**ESTABLISHMENT OF A WIND ENERGY FACILITY
SITUATED ON THE EASTERN PLATEAU (SOUTH)
NEAR DE AAR, NORTHERN CAPE PROVINCE**

**APPLICATION FOR AMENDMENT OF THE ENVIRONMENTAL
AUTHORISATION (EA), INCLUDING EXTENSION OF THE EA
VALIDITY PERIOD**

**PART 1 EA AMENDMENT APPLICATION:
DRAFT AMENDMENT MOTIVATION REPORT**

DFFE Reference number: 12/12/20/2463/1/AM9

Figure 2: Final Layout Plan
De Aar 2 South WEF

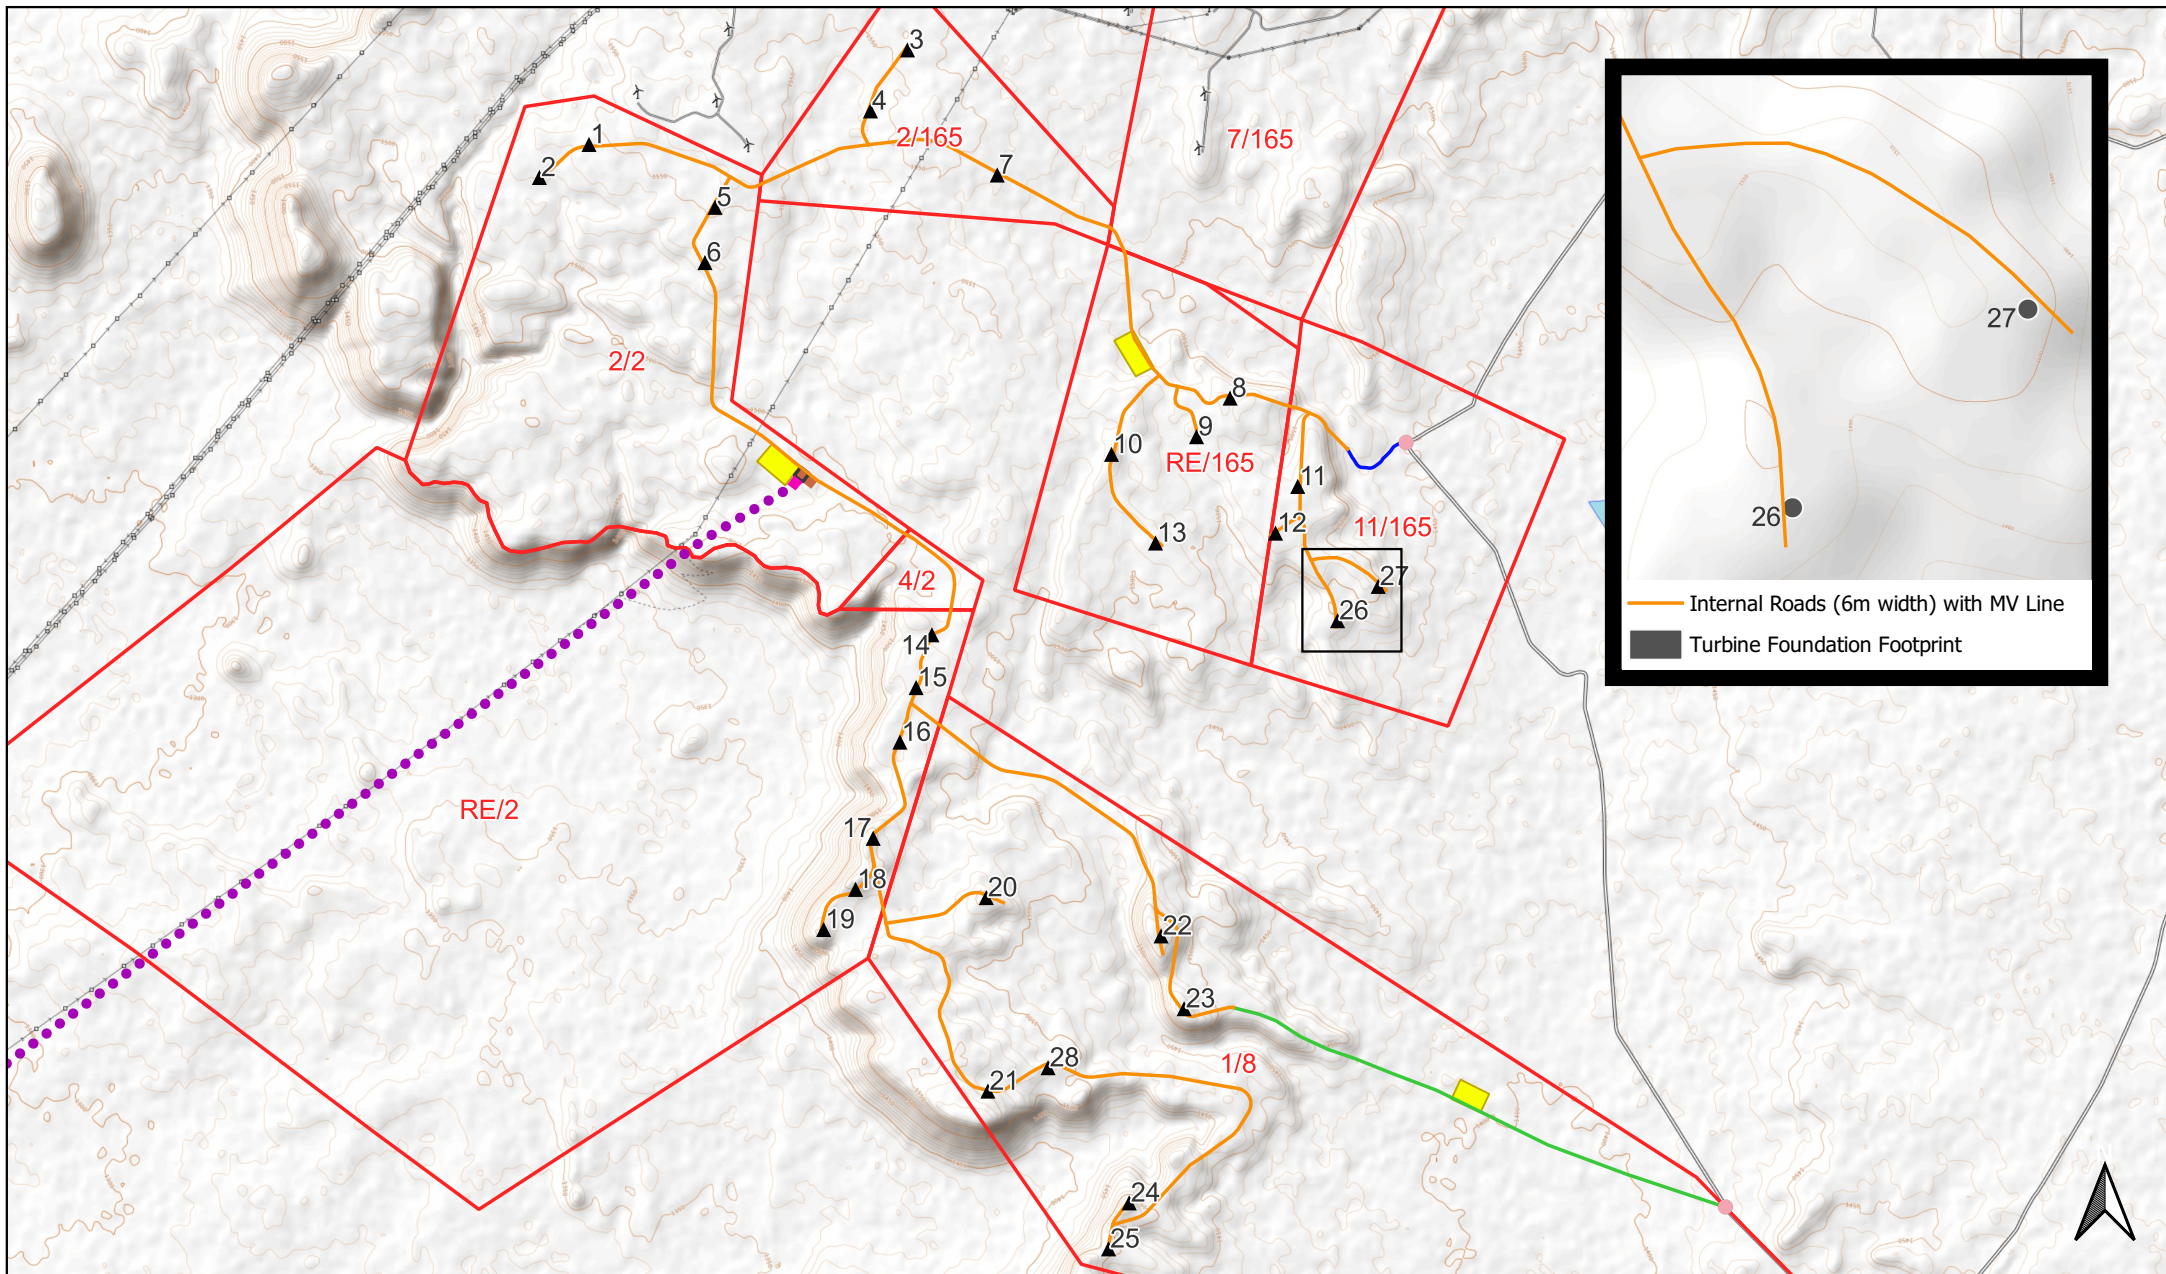
The proposed final Site Layout Plan (Figure 2) for the Mulilo De Aar 2 South WEF is currently out for public comment as part of the separate EMPr and Layout Plan finalisation process (as required in terms of Conditions 13, 14, 15 and 16 of the EA). The proposed final Site Layout Plan was guided by the Environmental Sensitivity Map which resulted from updated specialist assessments and inputs (September – November 2022). The Environmental Sensitivity Map is included in Figure 10 in Section 3 of this report.

Figure 6: Latest proposed layout (proposed Final Layout Plan (November 2022)) (green icons), set against the originally assessed 103 turbines (yellow balloons) and currently authorised 61 turbine layout (white squares)

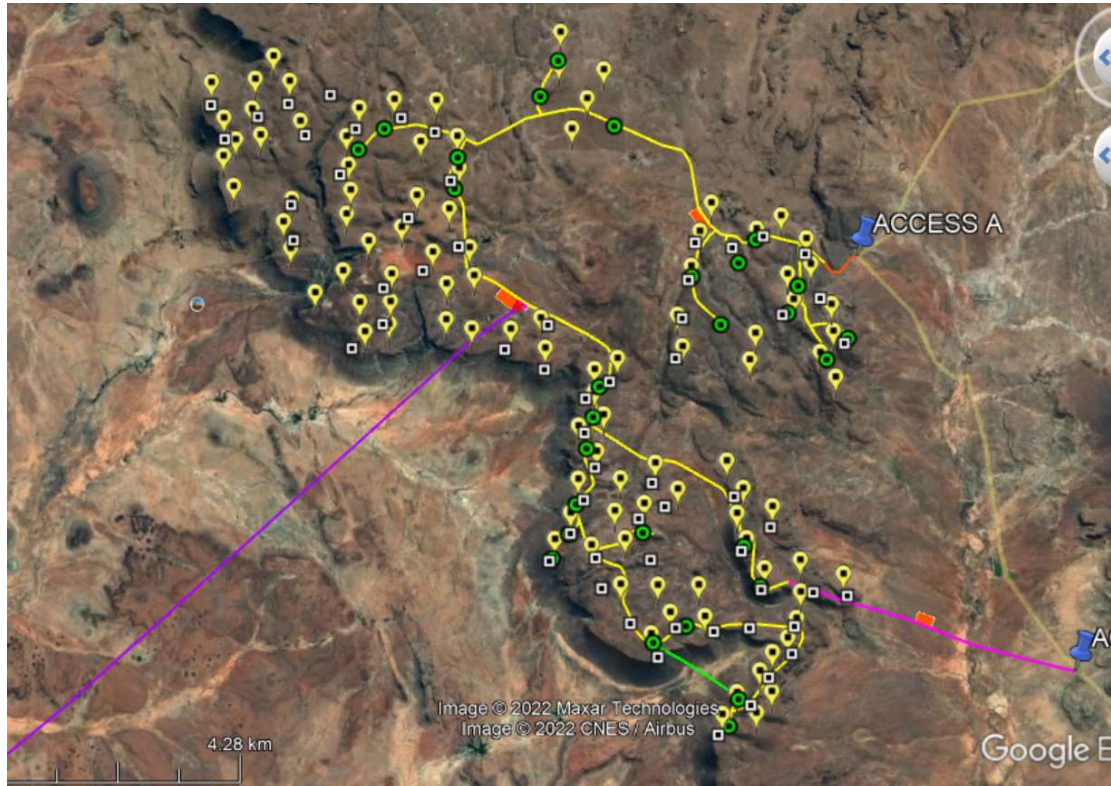
The current EA amendment application includes a reduction in the authorised number of turbines to be constructed to a maximum of 26 (down from a maximum of 61). The image below shows the latest proposed layout (green icons), set against the originally assessed 103 turbines (yellow balloons) and currently authorised 61 turbine layout (white squares). It can be seen that **the turbines are located in the same farms as originally assessed and within the same footprint area of the facility**. This provides evidence that the new (turbine) positions will remain within the assessed and authorised project footprint. Furthermore, all of the new proposed 28 positions have been assessed and recently checked (either through desk to analysis, but with additional site visit work by the majority of specialists) in the specialist “walk through”/EMP update reports as part of the layout finalisation process and micrositing.

Figure 8: Section of proposed final road layout (yellow line) (showing a short section (approximately 260m) of access road, on Portion 7 of Farm 165).

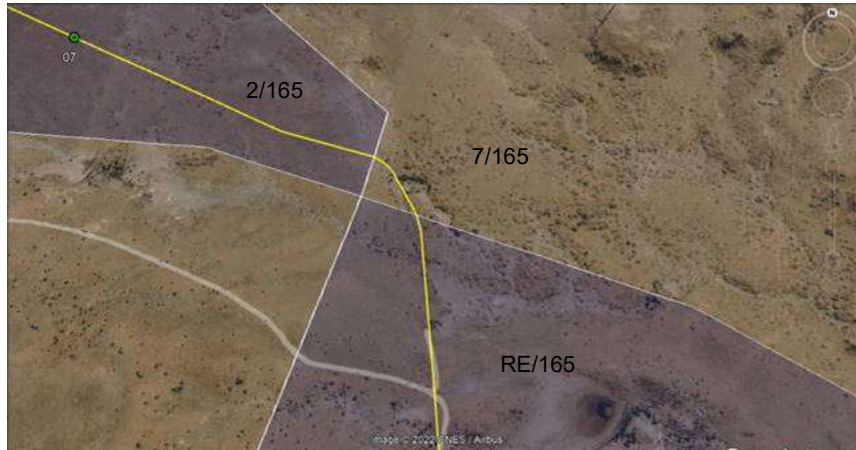
It became apparent to the Applicant during the finalisation of the Layout Plan for the project that there is a short section (approximately 260m) of a proposed internal access road that would cross a property (Portion 7 of Farm Vendussie Kuil No. 165) that was included in the combined Final EIA report (April 2012) for the De Aar 2 South WEF and De Aar 2 North WEF projects, and has been assessed by the specialists, however was erroneously not included in the Application Form and Environmental Authorisation (EA) for the De Aar 2 South WEF project. In this regard, as the holder of the EA progressed with the final design, they discovered that it is not technically feasible for the subject section of road to cross on a corner where four properties meet (refer to Figure 7 below which shows two properties shaded that are included in the EA). Therefore, the road needs to extend into the property to the north east (i.e. on Portion 7 of Farm No. 165) (as illustrated in Figure 8 below). Portion 7 of Farm No. 165 was included in the original EIA for the project (which was a combined EIA process and combined EIA report for the De Aar 2 North WEF and De Aar 2 South WEF), and whilst Portion 7 of Farm No 165 was included in the EA for the De Aar 2 North WEF project (which is now constructed and operational), it should also have been included in the EA for the De Aar 2 South WEF.

In light of the above, the Applicant would like to request for Portion 7 of Farm Vendussie Kuil No. 165 to be added into the EA for the project, given that it was included in the EIA process for the project **(and has been assessed again by the specialists during the recent EMPr and Layout Plan finalisation process in 2022)**, but was erroneously not included in the EA for the project.
